PRODUCT: 2021 DXL K-Series

TITLE: Pilot adhesive change

MODELS AFFECTED: DXL-060K thru DXL-235K

Photo 1: Original location of adhesive

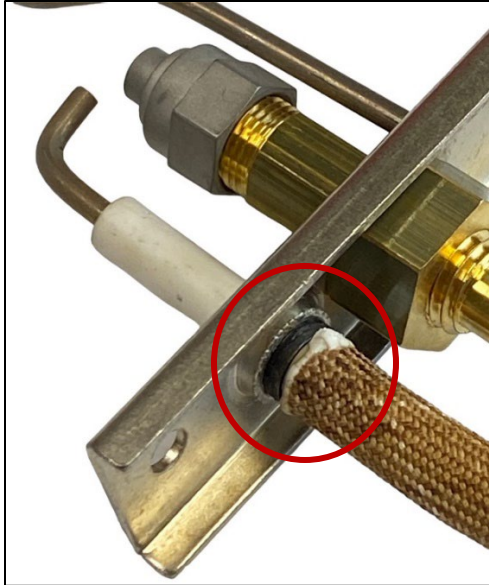
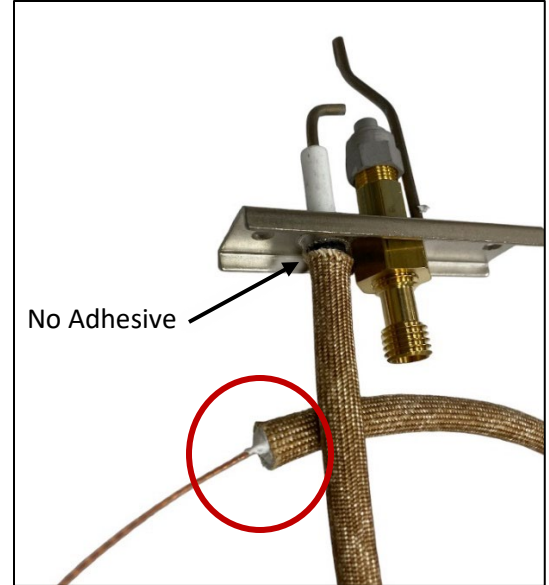
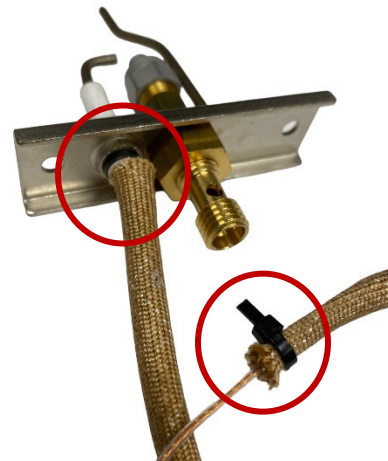
Infrequent field reports of nuisance failures associated with the DXL-K series boilers has prompted a change to the pilot assembly. The change eliminates any potential for electrical continuity created by the adhesive that holds the fiberglass sleeve in place. Electrical continuity in the area of the pilot ignitor can interfere with the flame rectification circuit and cause a nuisance shutdown.

The primary symptom is the pilot lights but the main burners are not activated. You may also notice in some cases that the ignitor continues to spark after the pilot is lit. For boilers utilizing the Resideo (Honeywell) S9361A control, the control may display an error E-57 or an erroneous error code.

To prevent any possible electrical continuity between the ignitor and ground the adhesive used to hold the fiberglass sleeve in place has been moved from the ignitor to the other end of the sleeve. This was a rolling change implemented in March of 2023. See photos 1 & 2.

1. Temporary fix: Roll back the fiberglass sleeve and remove the adhesive. The adhesive can be removed by scraping it away. Use a wire tie at the opposite end of the fiberglass sleeve to hold it in place so that the pilot end covers the igniter.

2. Permanent Fix: Replace the pilot assembly, kit no. 550003793. Ensure the new pilot does not have adhesive on the igniter end of the fiberglass sleeve.
